**ADDENDUM NO. 1**

**South River Fish Passage and  
Veterans Memorial Park Improvements Project  
Marshfield, MA**

September 6, 2024

**ADDENDUM NO. 1**

**RECONSTRUCT MEDIUM STONE WALL (4' < H < 6')**

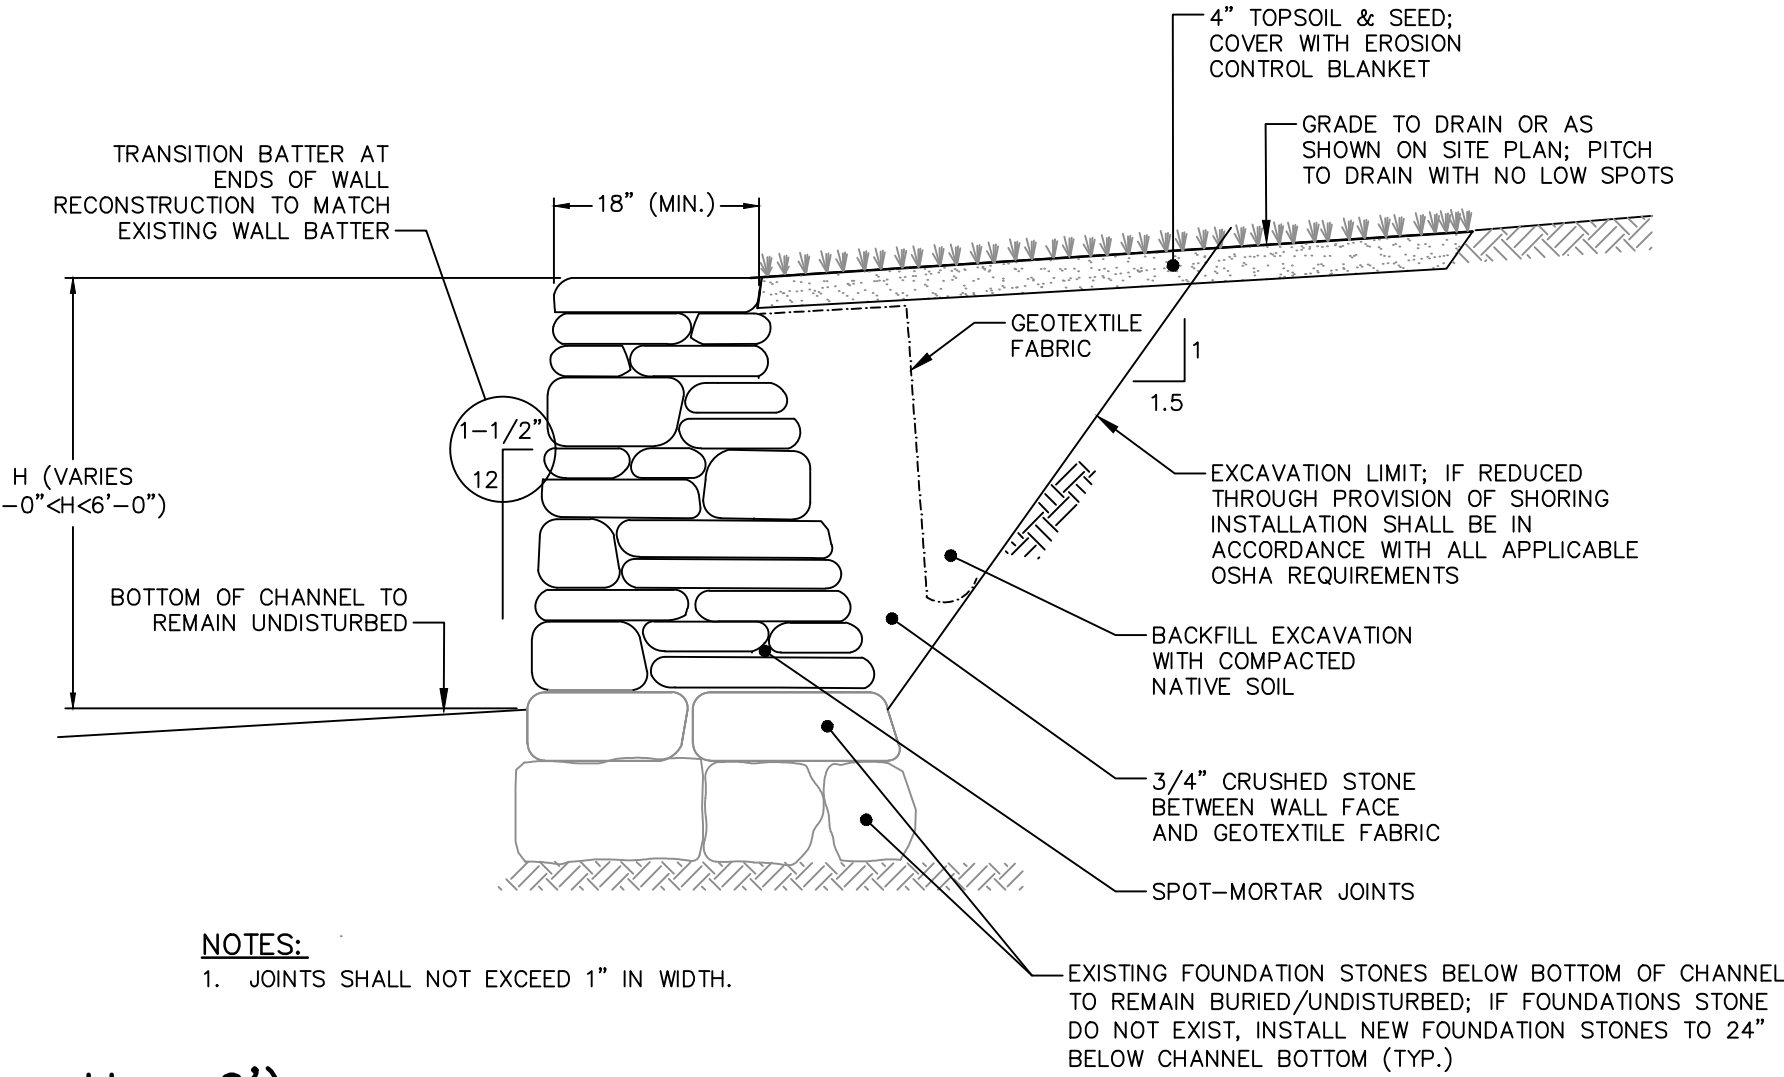
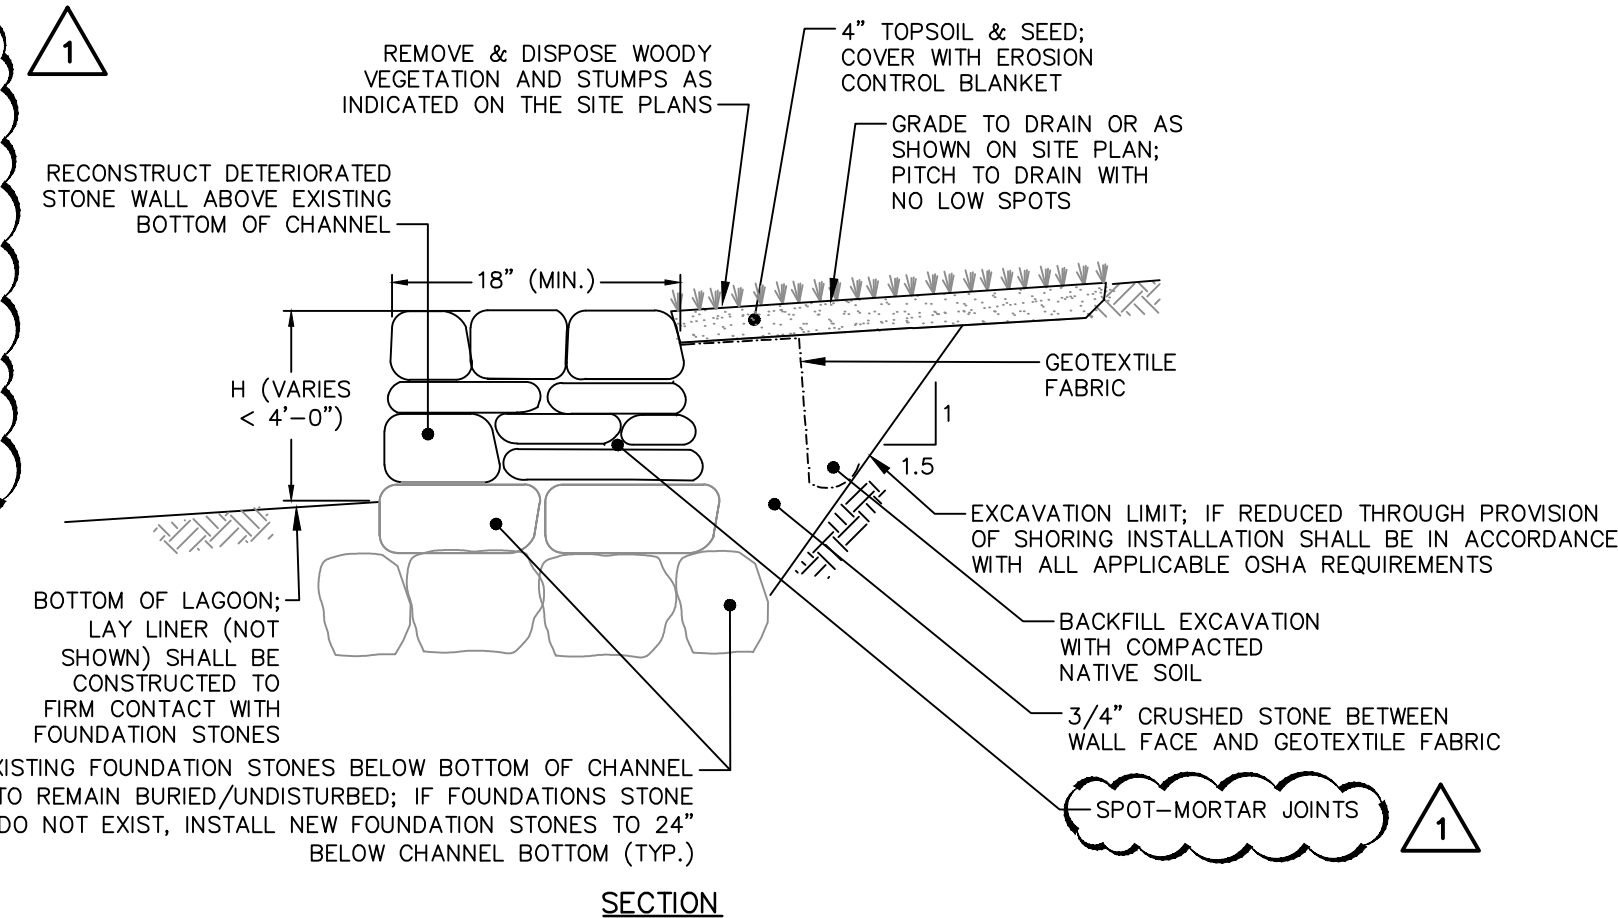
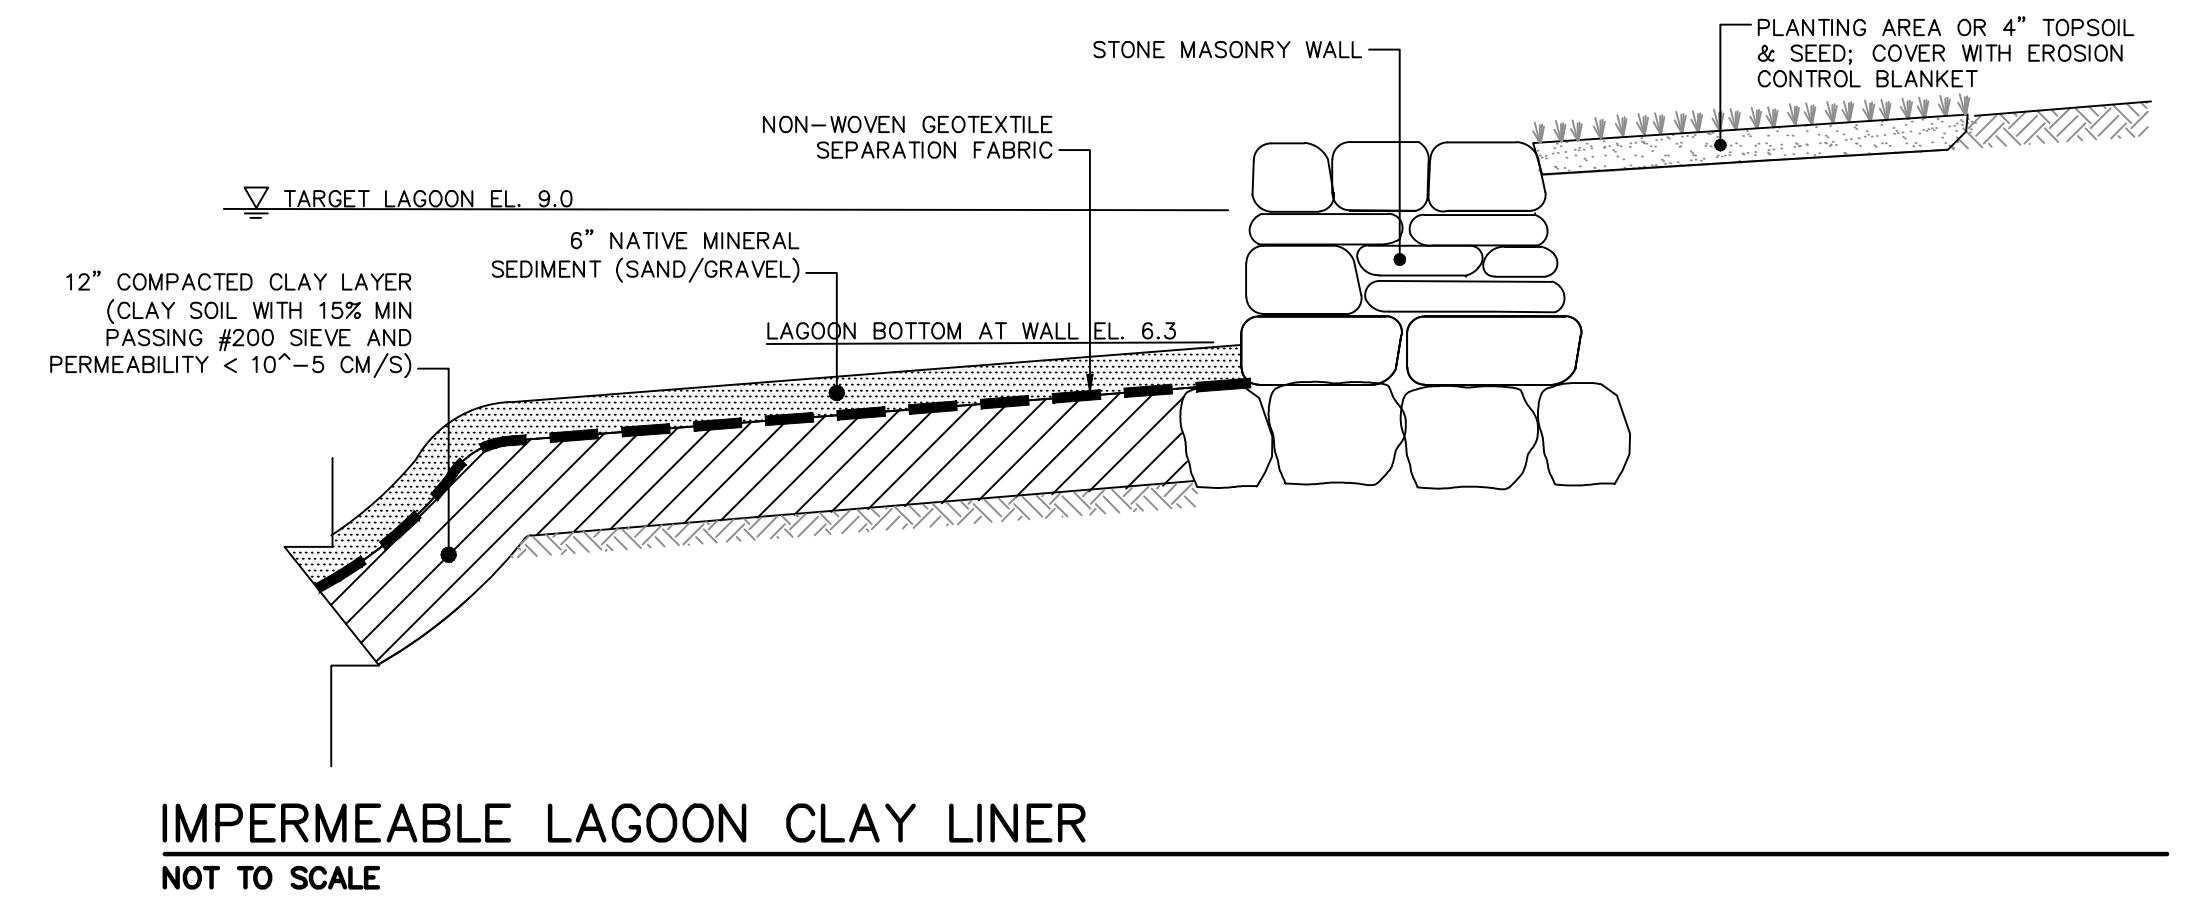
12. Delete *Section 04 43 00 – Stone Masonry* specification in its entirety and replace with the revised Stone Masonry specification provided in Attachment D.

- SPOT-MORTAR NOTES:**
1. SPOT-MORTAR JOINTS BETWEEN PLACED FOUNDATION STONES AND INTERIOR PORTIONS OF REPAIRED WALL.
  2. MORTAR SHALL NOT BE PLACED IN FIRST COURSE ABOVE FOUNDATION STONES TO ENSURE FREE DRAINAGE.
  3. MORTAR SHALL BE PLACED IN JOINTS ABOVE FIRST COURSE TO SECURE STONES IN PLACE WHILE ALLOWING FREE DRAINAGE. MORTAR SHALL NOT BE VISIBLE ON THE WALL FACE.
  4. ALL MORTAR SHALL BE CAREFULLY REMOVED FROM EXPOSED JOINTS ON WALL FACE; NO MORTAR SHALL BE VISIBLE UPON COMPLETION OF WORK.

- LOW STONE WALL REPAIR NOTES:**
1. THE SIZE, COURSE, ORIENTATION, AND PLACEMENT OF STONES SHALL MATCH THE EXISTING STONES AND BLEND WITH ADJACENT WALL SECTIONS. THE CONTRACTOR SHALL TAKE PRECONSTRUCTION PHOTOGRAPHS OF THE COMPLETE SURFACE OF EACH WALL TO BE REPAIRED FOR ARCHIVAL AND COMPARISON PURPOSES.

**TYPICAL STOP LOG CONTROL STRUCTURE DETAILS**

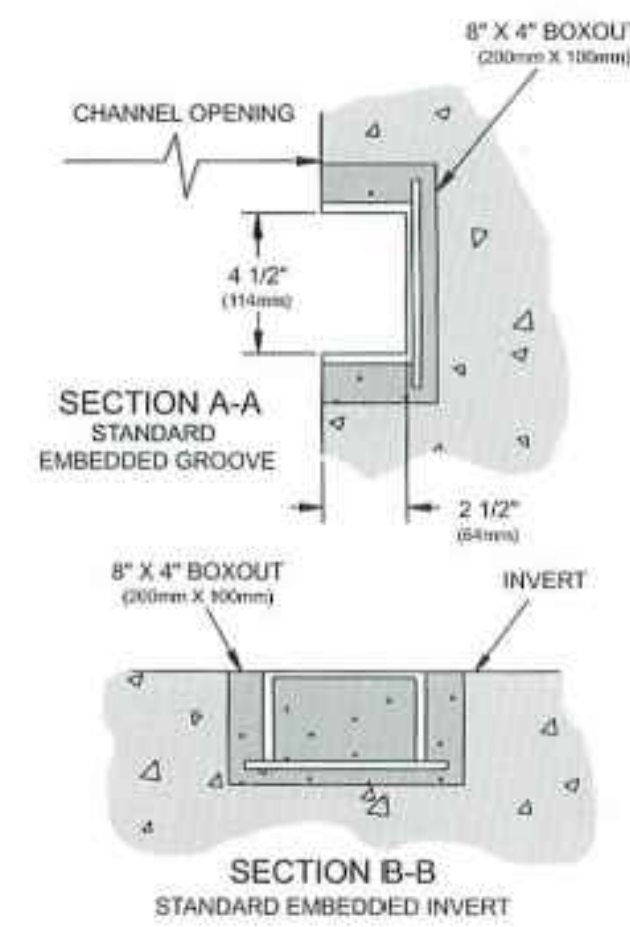
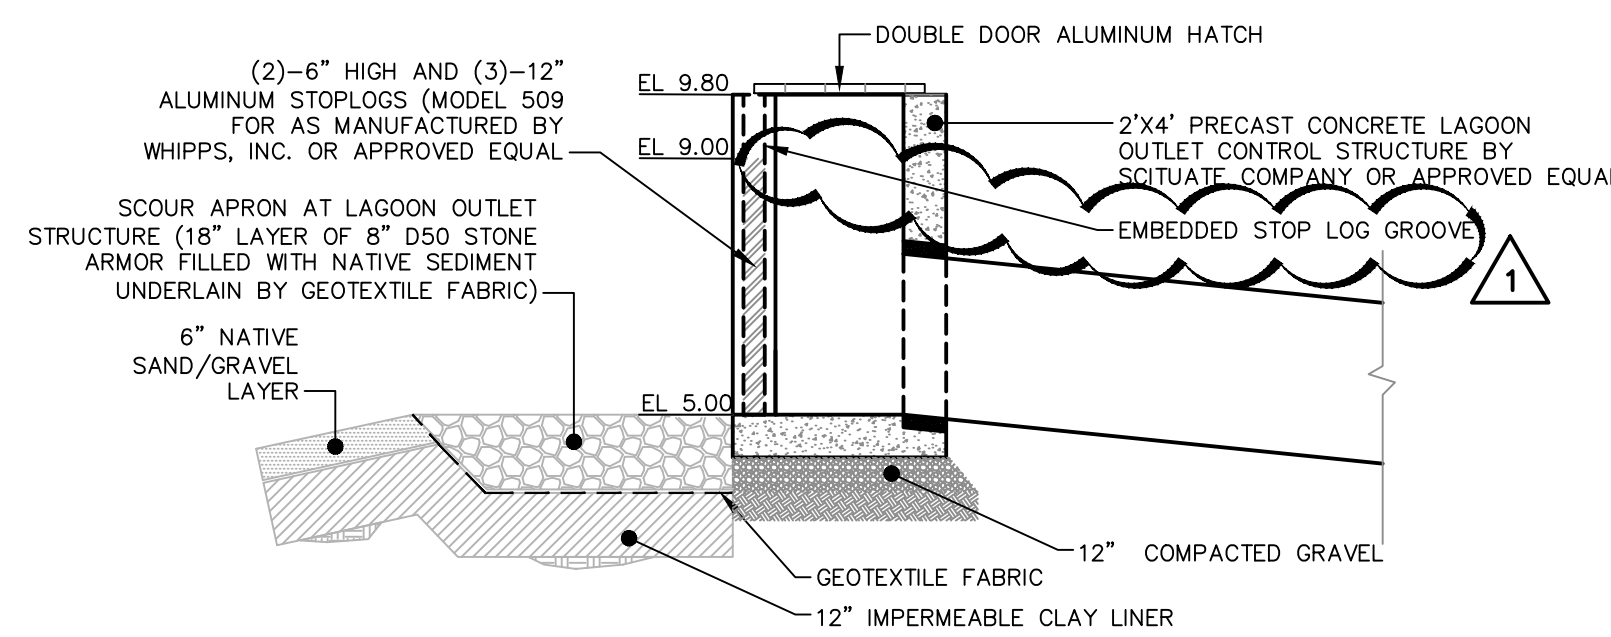
31. Question #14 – The specification calls out for the log frames to be made from aluminum, however the drawings CD-502 and CD-506 state Stop Log Channel Mounted Grooves to be constructed of formed Stainless Steel. Can you please clarify what material is to be used?

- STOP LOG NOTES:**
- STOP LOGS SHALL BE 6" HIGH ALUMINUM STOP LOGS (MODEL 509 AS MANUFACTURED BY WHIPPS, INC. OR APPROVED EQUAL).
  - STOP LOG EMBEDDED CHANNELS SHALL BE CONSTRUCTED OF FORMED STAINLESS STEEL AND SHALL BE FORMED AND WELDED WITH INTEGRAL CONCRETE ANCHORS FOR EMBEDDED APPLICATIONS.
